7th Response Submittal to EPA

January 19, 2005

C-14-1 Figure 2-37 Revision

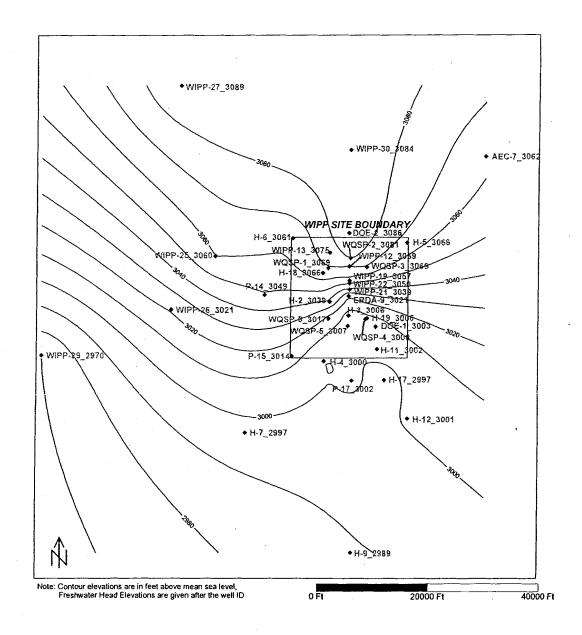
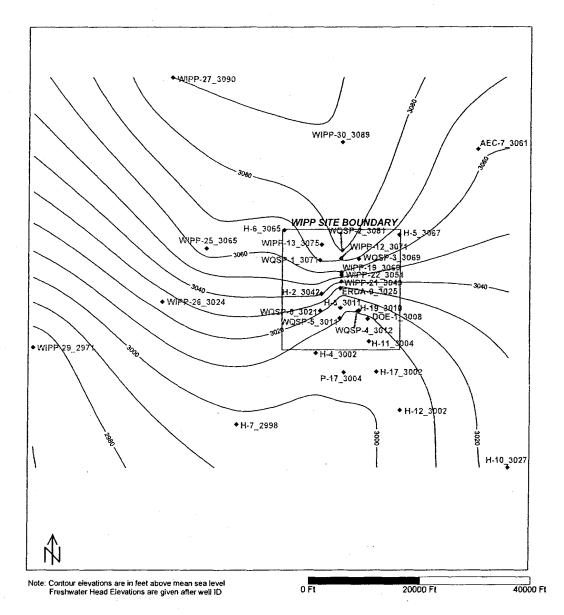
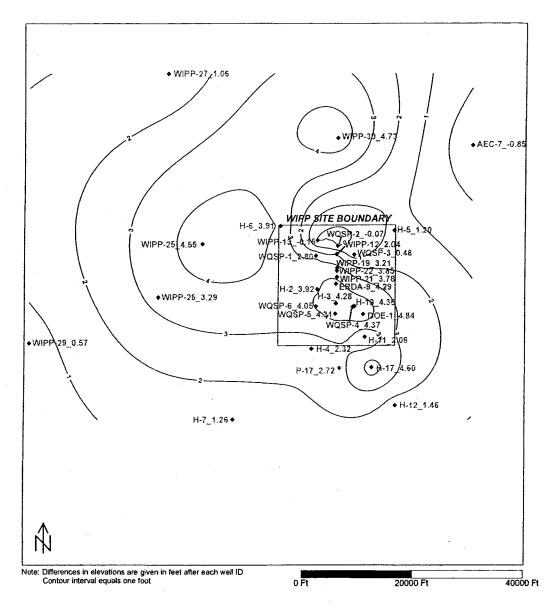
"Figure 2-37 does not include the data points from which the contours were drawn. Additionally, the figure does not indicate the monitoring cycle/time period represented by this surface, and related text does not indicate whether there are mappable fluctuations in the potentiometric surface based on the monitoring period. DOE must revise Figure 2-37 to include this information, and to address periodicity associated with water level fluctuations, if observed. If water level fluctuations were not observed, DOE should so state."

Figure 2-37 should be replaced with the following three figures (Figures 2-37a, 2-37b, and 2-37c), and the following text should be inserted in Chapter 2 at the top of page 2-112.

"Potentiometric surface maps of the freshwater head in the Culebra in December 1998 and December 2002 are shown in Figures 2-37a and 2-37b, respectively. The maps are generally similar and indicate no changes in flow directions across the WIPP site over that period. Figure 2-37c shows the changes in heads at the wells monitored in both December 1998 and December 2002. Freshwater heads in most wells increased by 2-4 ft from 1998 to 2002. The largest rise was 4.84 ft at DOE-1. Only one well, AEC-7, showed a drop over this period (-0.85 ft) larger than potential measurement error."
